# Hammersmith Bridge

Review of Recent Documents and  
Summary of Existing Condition

Department for Transport

AECOM UK  
Sunley House  
4 Bedford Park,  
Croydon,  
Surrey,  
CR0 2AP

Figure 3.1: Extract from CCSO for Limited River Traffic

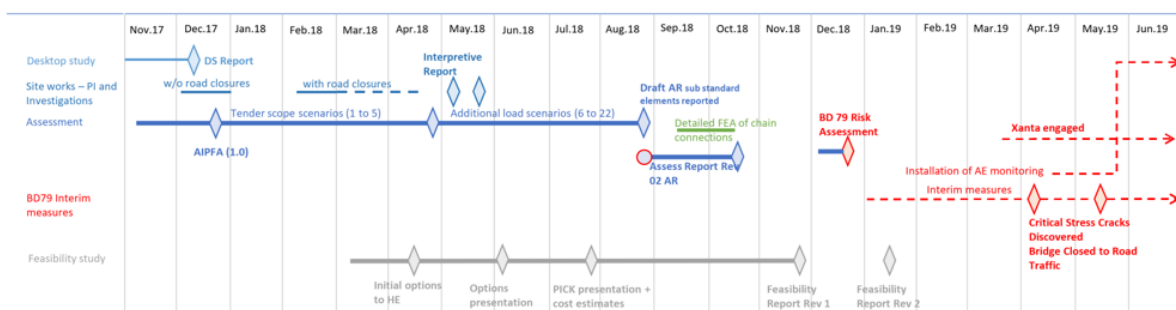
to consider if considering temperature range up to the maximum temperature.			
A10	In the CCSO for Limited River Traffic Movements Draft 4 (Oct 2020), Appendix 1 Timeline and Risk Profile – why is there no reduction in the risk in March/ April after the more refined analysis of the pedestal had reduced the UF for the SW pedestal to 1.24.	02/11/20		
A11	In the CCSO for Limited River Traffic Movements Draft 4 (Oct 2020), Appendix 1 Timeline and Risk Profile, there is a combined change in risk from the installation of additional AE sensors (in dotted line) but mitigated by the reduction in frequency of inspections. What is the overall net change in risk?	02/11/20		
A12	In the CCSO for Limited River Traffic Movements Draft 4 (Oct 2020), Appendix 1 Timeline and Risk Profile – there is a reference to carbon fibre plate bonding study – is this available for review?	02/11/20

Figure 4: Relative saddle position

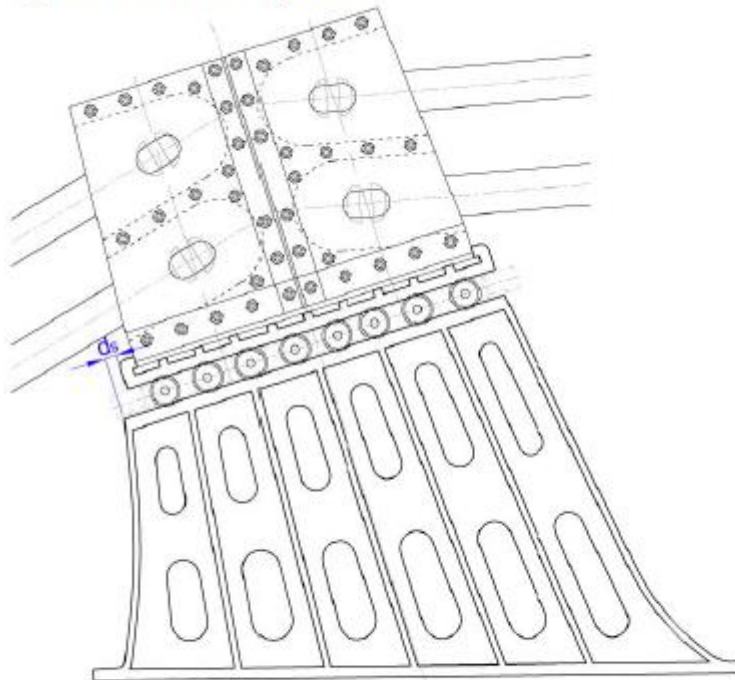
The position of the saddle at time of construction is not known but for the saddle positioned centrally with respect to the pedestal,  $d_s = 38\text{mm}$ . Refer to Table 1 for a summary of measured relative saddle positions.

Figure 4.2: Extracts from MM report showing Utilisation Factors

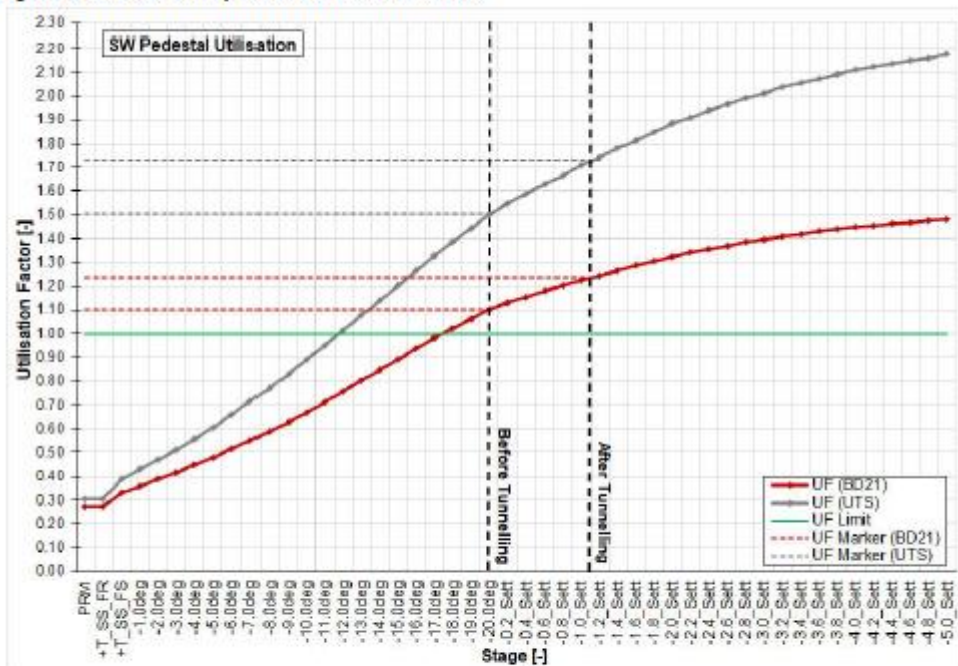
In Figure 4.2, which is an extract from the MM report, it shows the UF for the SW pedestal much lower as 1.10, increasing to 1.24 after the effects of TTT are included. Adding 0.18 from pedestrian loading takes the UF up to 1.42.

Figure 4.3: MM Soil-structure interaction model

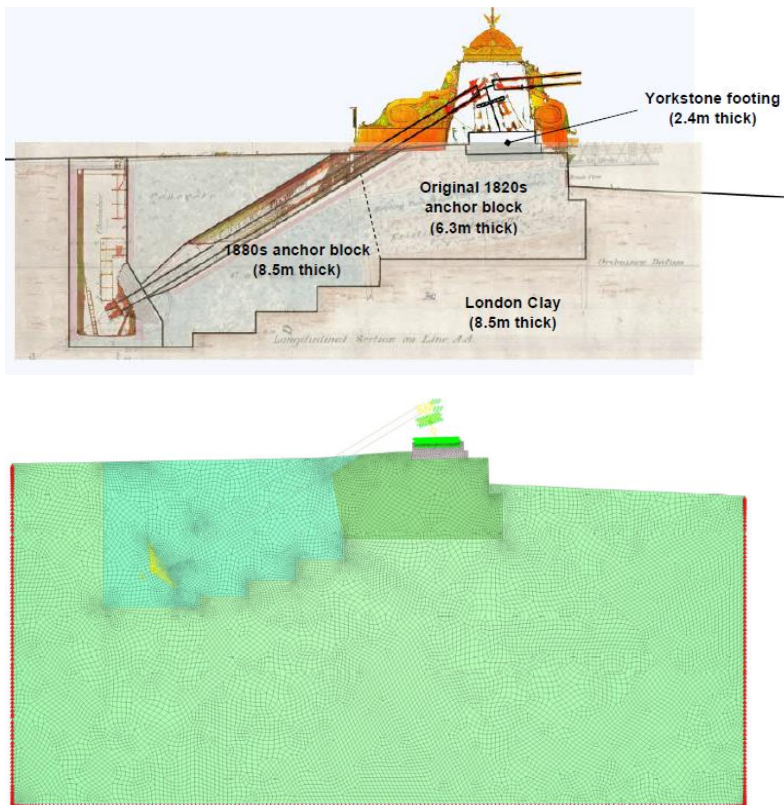
- It has been established through discussion and comments sheets AECOM understands that the presence of the previous chain tunnel has been included in the analysis of the ground conditions. It is likely that the softer ground may help to dissipate the restraining force. The extracts in Figure 4.3 below show the geometry and the subsequent model used for the 2D analysis of the anchorage and ground.
